Project	<b>IEEE 802.16 Broadband Wireless Access Working Group</b> < <a href="http://ieee802.org/16">http://ieee802.org/16</a> >	
Title	<b>Proposal for Double Uplink Scheme in OFDMA</b>	
Date Submitted	<b>2004-07-07</b>	
Source(s)	<i>Bin-chul Ihm, Kyuhyuk Chung, Jin-young Chun, Yongseok Jin</i> LG Electronics, Inc. 533,Hogye-1dong, Dongan-gu, Anyang-shi, Kyongki-do, Korea	Voice: 82-31-450-7903 Fax: 82-31-450-7912 <a href="mailto:jychun03@lge.com">[mailto:jychun03@lge.com]</a>
Re:	<i>This is a response to a Call for Comments IEEE802.16e-04/xx on IEEE P802.16e-D2</i>	
Abstract	<i>Proposal for Double Uplink Scheme in OFDMA</i>	
Purpose	This document is submitted for review by 802.16e Working Group members	
Notice	This document has been prepared to assist IEEE 802.16. It is offered as a basis for discussion and is not binding on the contributing individual(s) or organization(s). The material in this document is subject to change in form and content after further study. The contributor(s) reserve(s) the right to add, amend or withdraw material contained herein.

# Proposal for Double Uplink Scheme in OFDMA

Figure yyy – MIMO tile in UL PUSC mode

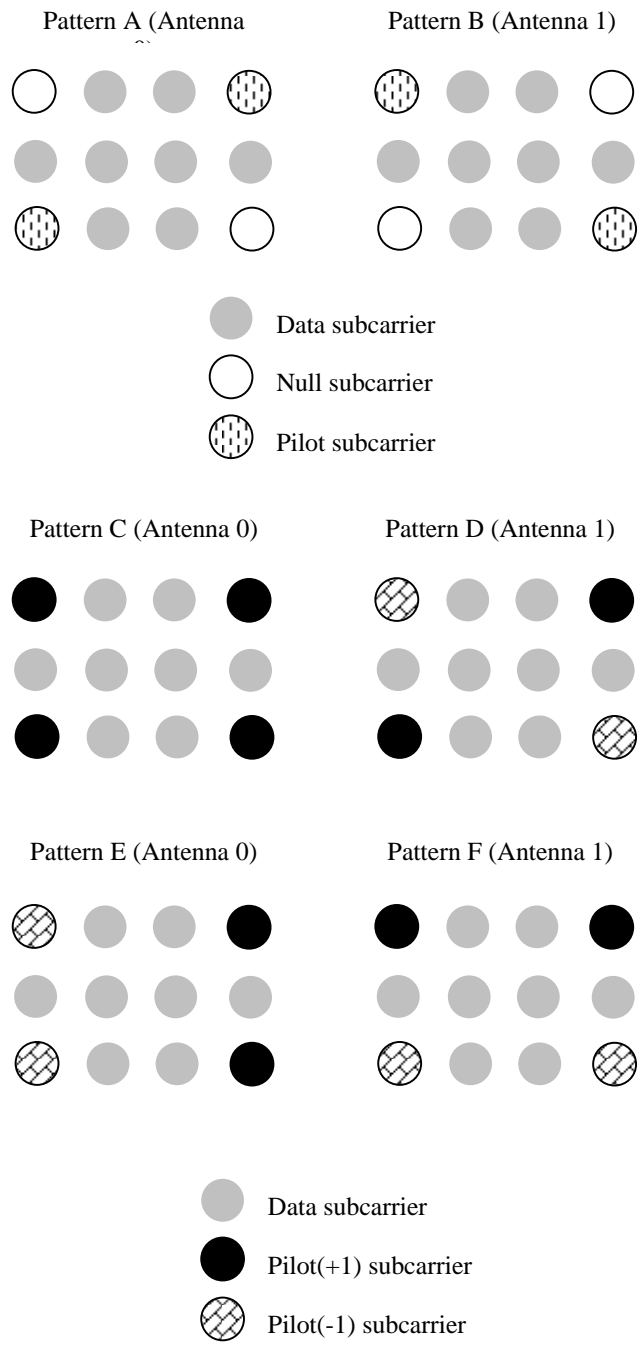
A user supporting transmission using STC configuration in the uplink, shall use a modified uplink tile, 2-transmit diversity data or 2-transmit spatial multiplexing data can be mapped onto each subcarrier, the mandatory tile shall be modified to accommodate those configurations. Figure yyy depicts the UL tiles for enhanced STC transmission in PUSC mode.

Two single transmit antenna SS's can perform collaborative spatial multiplexing onto the same subcarrier. In this case, each SS should use the uplink tile with the pilot pattern indicated in MIMO\_UL\_Enhanced\_IE.

A dual transmit antenna SS can use the allocation in STTD, SM or collaborative SM mode with other dual transmit antenna SS. Each SS in collaborative SM mode with dual transmit antenna sends data in ordinary STC configurations as in section 8.4.8.1.4 using the pilot pattern pair indicated in MIMO\_UL\_Enhanced\_IE. The first pilot pattern in each pair is for antenna 0 and the second is for antenna 1.
